Pre-Filed Testimony of Dr. Patrick Lucia

**PCHB No. 01-160
*ACC & CASE v. Dept. of Ecology & Port of Seattle***

February 27, 2002

Figure 1a: Less Contaminated Fill Zone under August 401 Certification

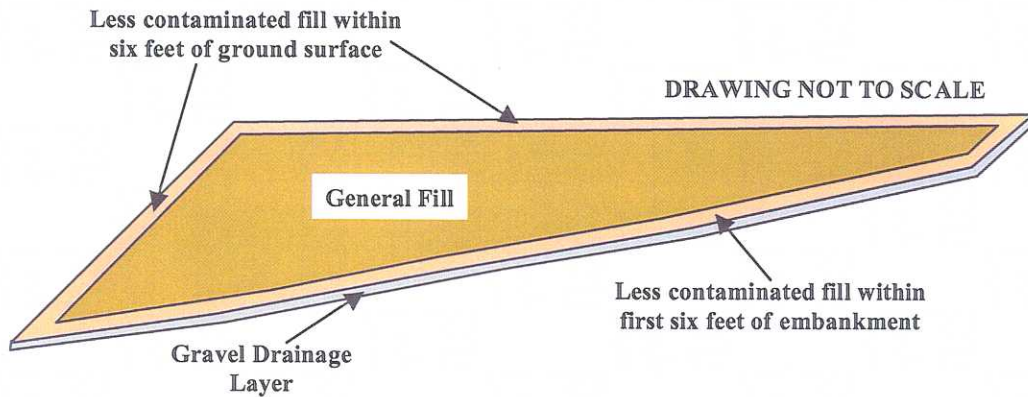
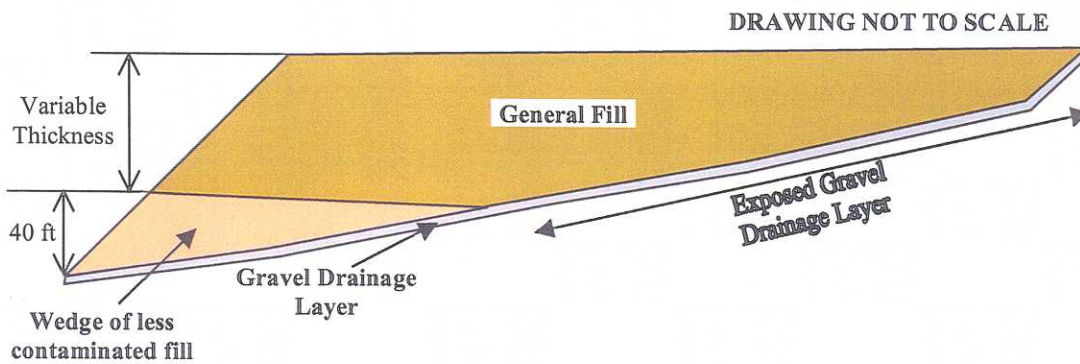
This proposed “wedge” alternative is included on page 18 of the September 21, 2001 Department of Ecology revised 401 Certification and is presented as an alternative to the previous soil fill criteria, rather than an addition. The proposed alternative would only apply the more stringent restrictions on the level of hazardous substances in a wedge of fill above the drainage layer that measures 40 feet thick at the base of the embankment and tapers downwards at a 2% slope into the fill. This means that fill above the drainage layer over the upper two thirds of the embankment will contain higher concentrations of

hazardous substances than under the original screening criteria as shown in Figure 1. Higher concentrations of metals and petroleum products can be placed adjacent to the drainage layer and will not have an "ultra-clean" layer of fill to "attenuate any potential contamination that might be leaching through the rest of the embankment" as described by Ms. Gould. In addition, the changes from the August certification in the September certification will allow placement of higher concentrations near the ground surface, creating an increased impact on surface water runoff. The alternative clearly represents a reduction of the environmental standards for the project.

11. Under the August 10, 2001 certification requirements, Ecology required the Port to completely enclose the higher concentration fill within a six foot layer of fill with more stringent screening requirements, although to my knowledge there has been no analysis demonstrating the effectiveness of this method under these conditions. By itself, the alternative proposed in the September 21, 2001 certification represents a relaxation of the requirements, where the upper two thirds of the drainage layer are now exposed to soils with higher levels of metals and petroleum products. There does not appear to be any rationale given for this relaxation, nor any analysis demonstrating that a wedge of less contaminated fill placed immediately above the drainage layer in the configuration shown in Figure 1 meets an equivalent or more protective standard than the six-foot enclosure.

Figure 3a: Van Genuchten Parameter Variability

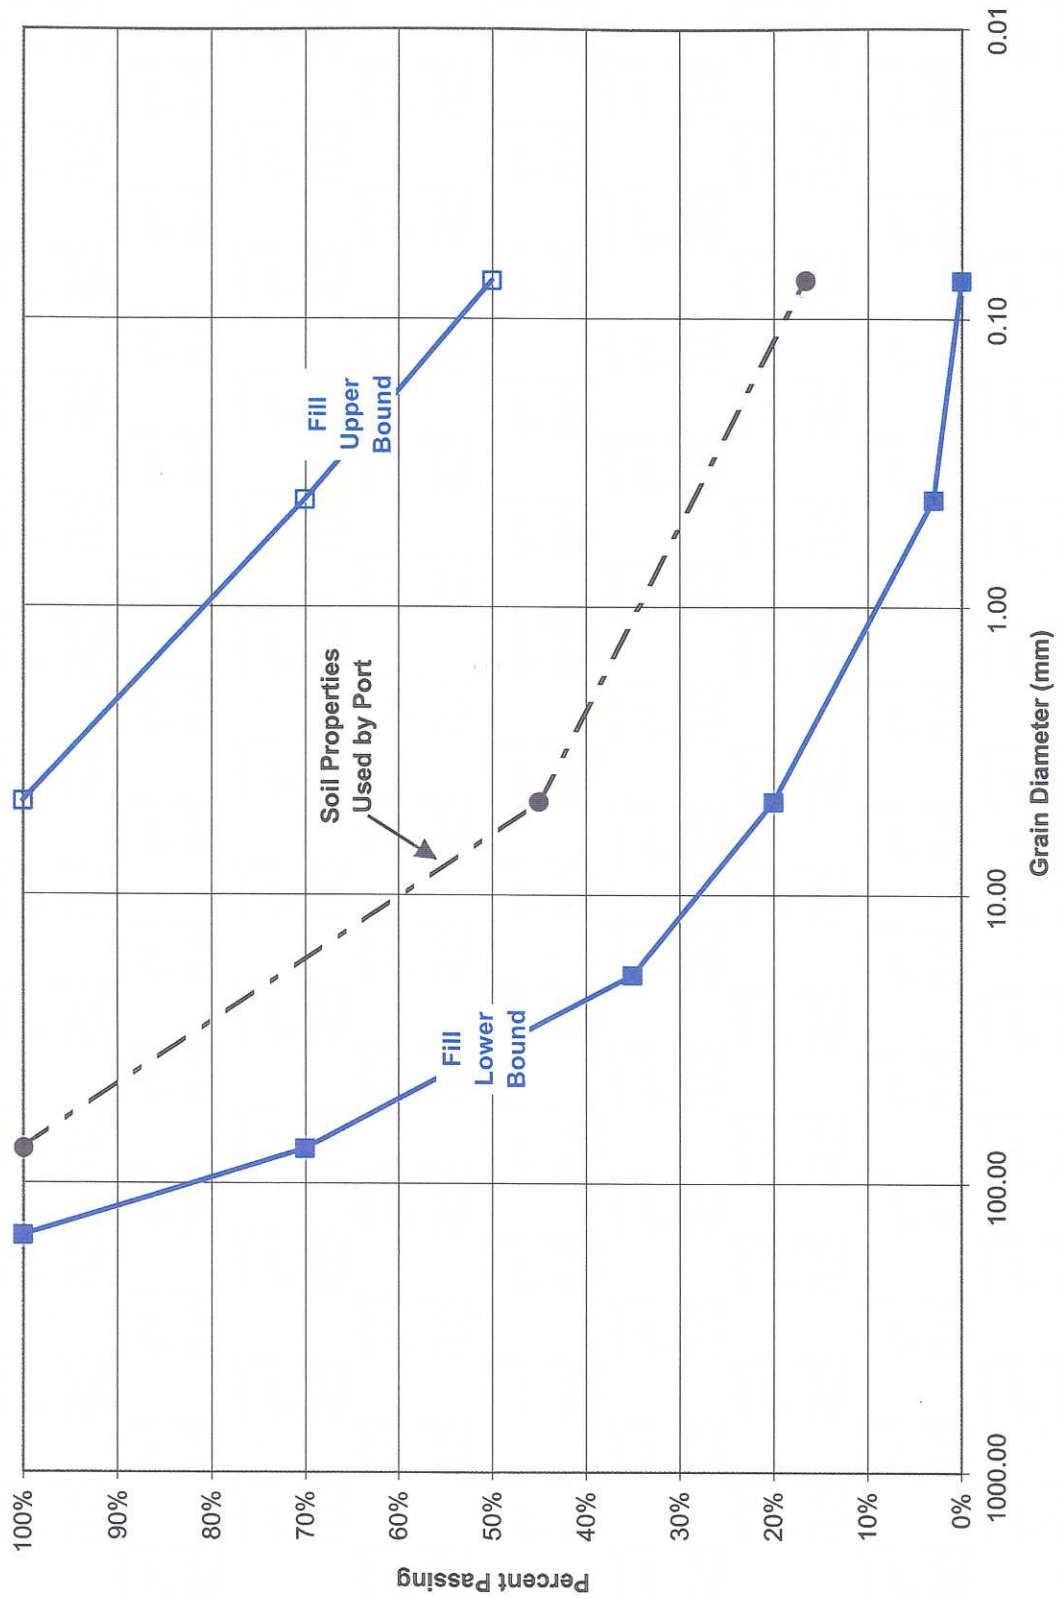
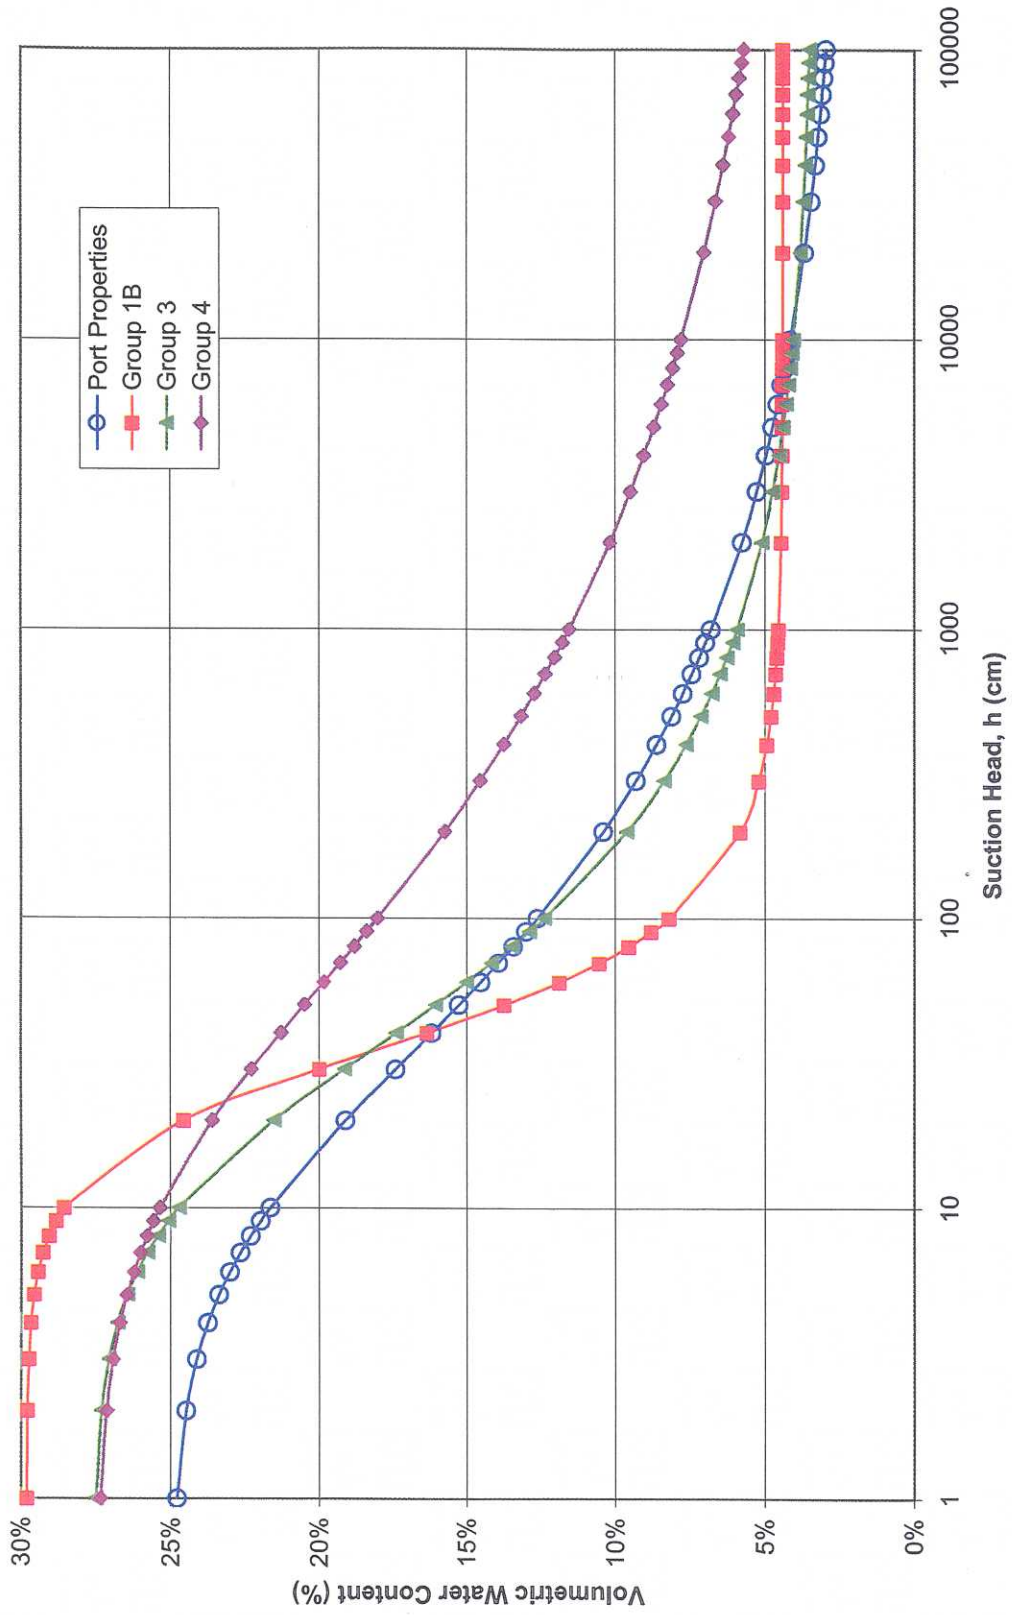
Figures 3a and 3b present the representative curves developed by Hart Crowser for the three fill types, along with the single set of curves being used presently by PGG in their Hydrus modeling (labeled "Port Properties"). Table 1 shows the input parameters used for each of the fill models. While Hart Crowser's modeling with the HELP program was overly simplistic and their method of accounting for gravel content was not well validated, their performance of parametric studies on the fill types was a step in the right direction compared to the single fill type currently being modeled in Hydrus. The Hart Crowser properties show that the hydraulic conductivity (which controls the rate at which water will pass through the fill) can range over several orders of magnitude for soils likely to be placed in the embankment. The figures clearly show that the single curve being used by the Port is not representative of the potential range of behavior.

Figure 4: 1-Dimensional Column Initial Lag Times for Infiltration to Reach Drainage Layer under Varying Soil Properties and Column Heights

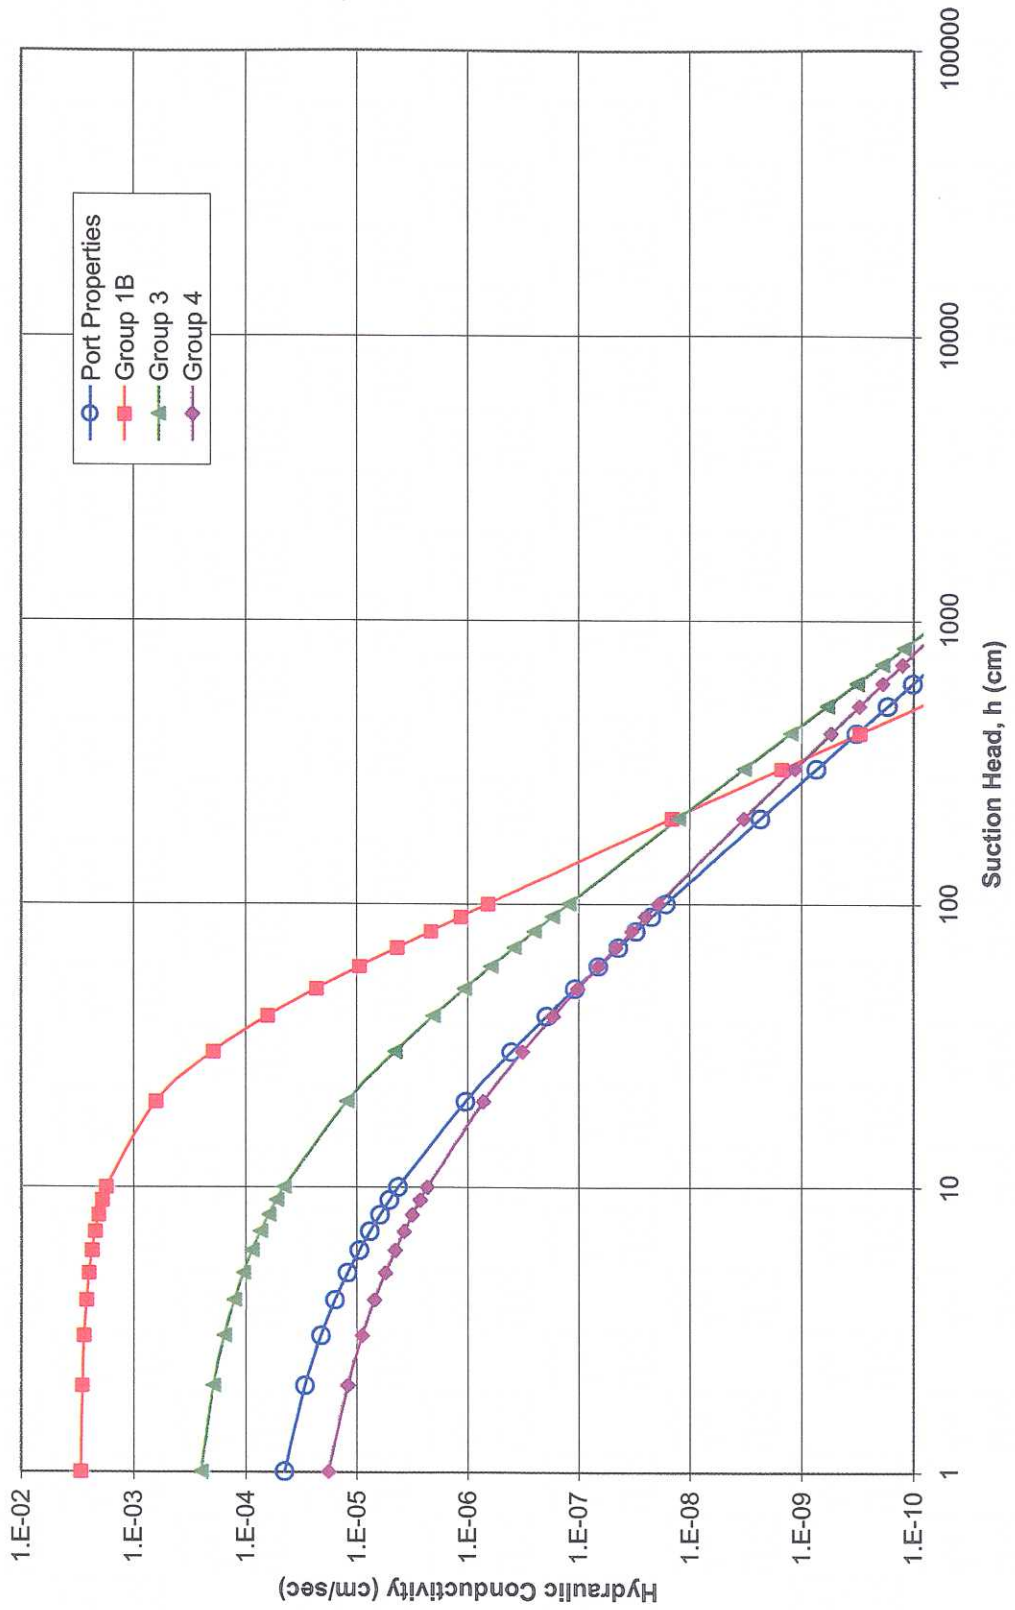
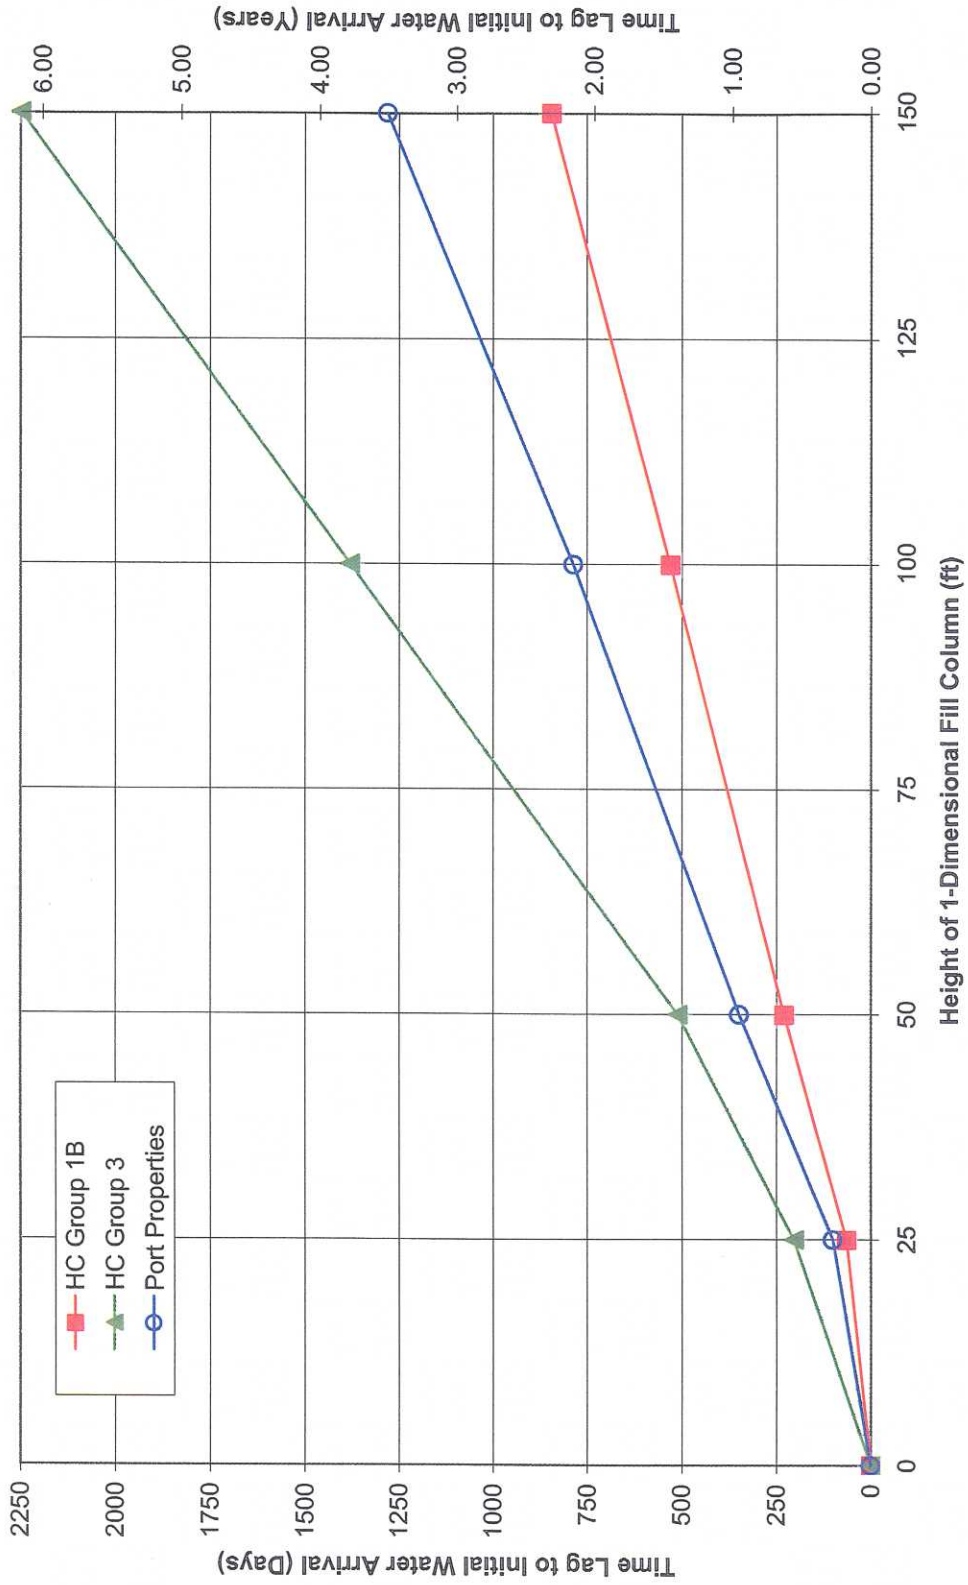
28. In order to demonstrate the influence of the variability of soil properties on the lag time between embankment construction and first arrival of water at the drain, several simple cases were analyzed. 1-Dimensional columns of varying fill thickness (25 ft, 50 ft, 100 ft, and 150 ft) were modeled using Hydrus for three different sets of fill properties (Hart Crowser Group 1B, Hart Crowser Group 3, and the Port Properties). The 1-Dimensional columns were modeled in a fashion similar to the Port's analyses, where all infiltration was assumed to travel vertically through the fill, without an allowance for horizontal flow. Figure 4 shows the results of these analyses. A curve is shown for each set of properties, immediately revealing the potential for variability in the results. Each point on the curves represents the time between the beginning of the analysis (Day 0) when the precipitation record begins, and the time when the first water reaches the drain at the

base of the column. As the height of the 1-Dimensional column is increased (i.e. as the embankment fill thickness increases) the time lag increases relative to the properties for each fill type. For example, for a 50 ft fill thickness, the range of time lags shown is 250 to 500 days (approximately 0.7 to 1.4 years), and for a 150 ft fill thickness, the range is 850 to 2250 days (approximately 2.3 to 6.2 years). It will be shown later that ignoring the horizontal flow component in the fill (i.e. performing a 1-Dimensional analysis) results in an overestimation of the rate at which water flows through the fill, and thus the predicted lag times will actually be even longer than these values. In any case, the differences clearly demonstrate the potential variability in results, which the Port is ignoring in their analyses. Incorporation of this type of parametric study in the Port's analysis will likely have a significant impact on the design of the Port's low flow mitigation scheme and is absolutely necessary for proper representation of the possible impacts of the embankment fill.

Figure 5a: Current Model System, all flow travels vertically through sand & silt matrix

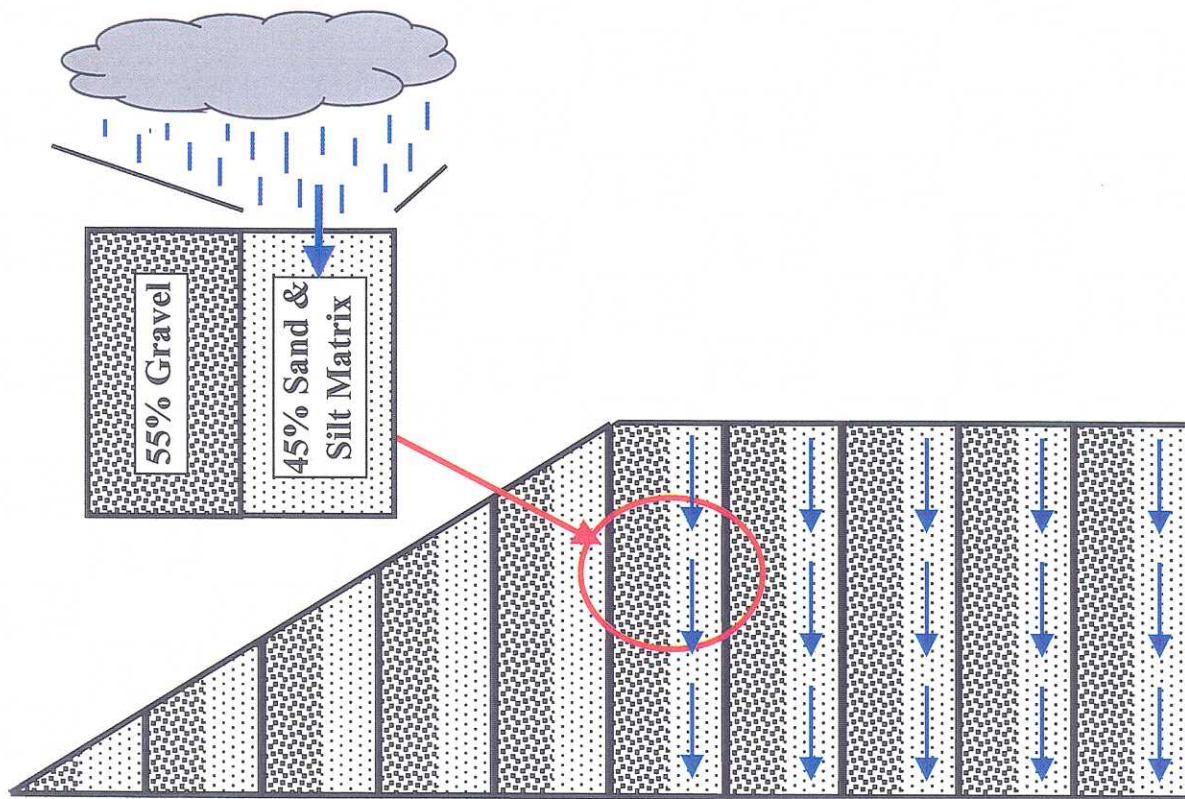
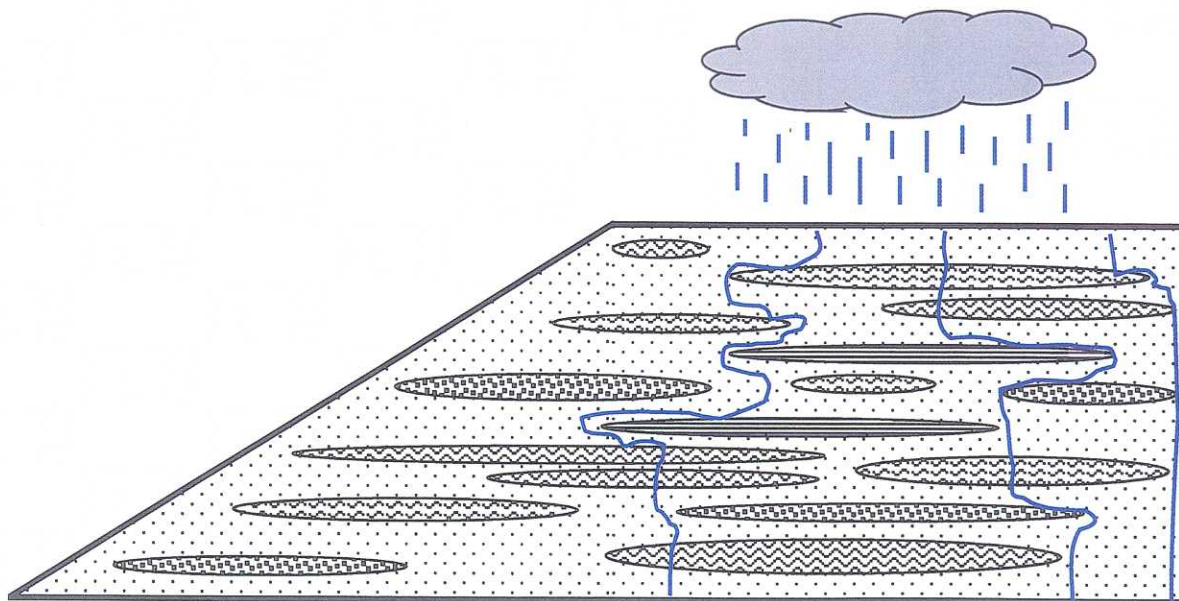
33. The Port's method of modeling of flow through the fill as a 1-Dimensional phenomenon using Hydrus is an oversimplification of a truly 3-Dimensional process, and will result in an overprediction of the rate at which water travels through the embankment. In addition to the Port's ignoring the gravel content of the embankment fill, their analysis consists of a series of 1-Dimensional columns of soil of varying thickness which force the infiltrating water to travel downward unimpeded without any lateral migration. Figure 5a shows a schematic of the system the port is actually modeling. Each column theoretically consists of 55% gravel and 45% sand and silt. However, water falling on any given column of soil is forced through the sand and silt matrix (achieved through artificial adjustment of precipitation and discharge quantities), bypassing the gravel completely. It should also be noted that water falling on the sloping face of the embankment is assumed not to infiltrate at all, and because the water can only travel vertically, this region never sees any water at all.

34. Figure 5b shows a schematic (which is still a simplification) of the type of layering that will exist in the embankment fill as a result of the construction process. 20,000,000 cubic yards of fill will be imported from numerous borrow sources and placed in horizontal layers at the then current elevation. The soil layers with the lowest hydraulic conductivity will control the vertical rate of flow of water traveling through the embankment. It will be impossible for the Port to control the fill sufficiently that an assumption of uniform flow behavior can be assumed realistically. The Port has failed to consider the very real variability of the soils that will be placed in the embankment. As a result of the fill layering, the flow path will be significantly more complex than represented

by the Port (e.g. Figure 5a), and the time for water to travel through the embankment will be much slower than predicted. Surface sloughing, which I observed on the slopes of the constructed embankment is evidence of the layering in the fill. The infiltrating water is being directed horizontally to the slope increasing the seepage emerging from the slope leading to the observed sloughing.
